EXHIBIT "A"

City of Mansfield
Amendments to the
2006 International Residential Code
North Central Texas Council of Governments Region

Figure N1101.2 TEXAS CLIMATE ZONES

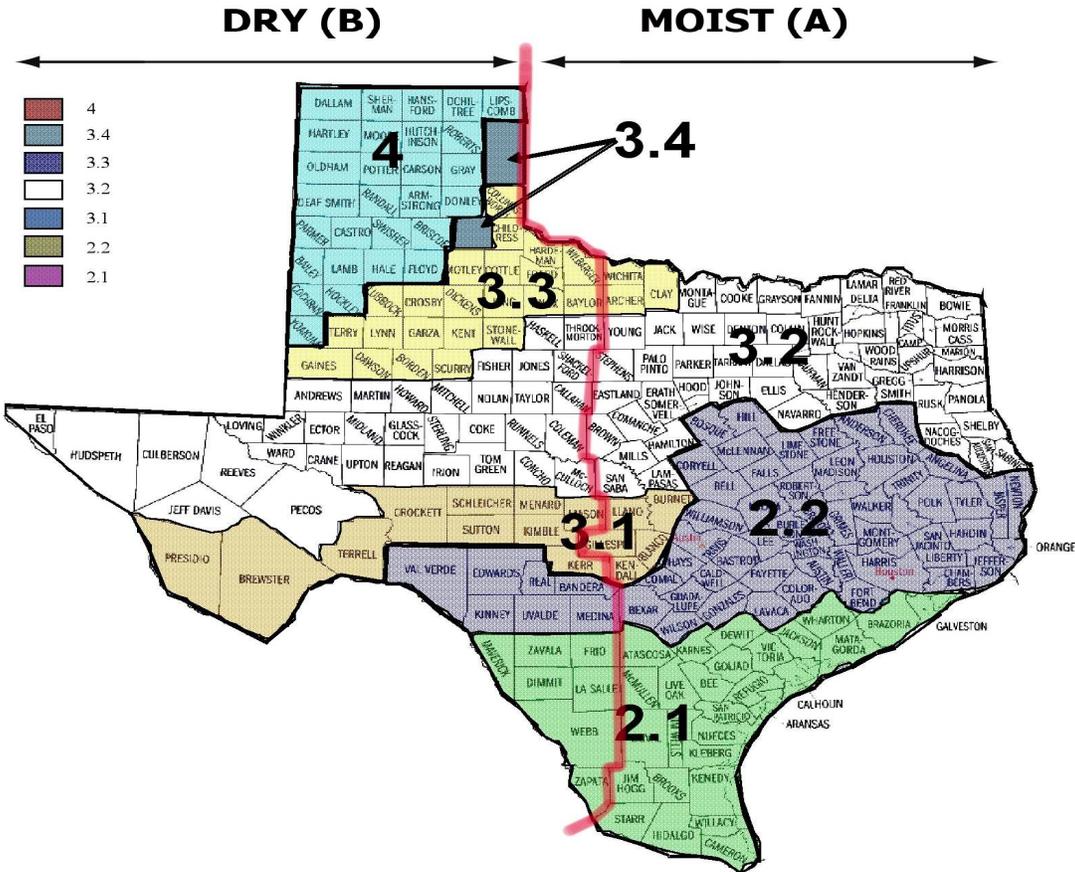
Replace Figure N1101.2 to read as follows:

Reason: This amendment is added to satisfy the "not less restrictive" requirement when adopting subsequent editions of energy codes in accordance with Texas SB 5, 77th Legislature.)
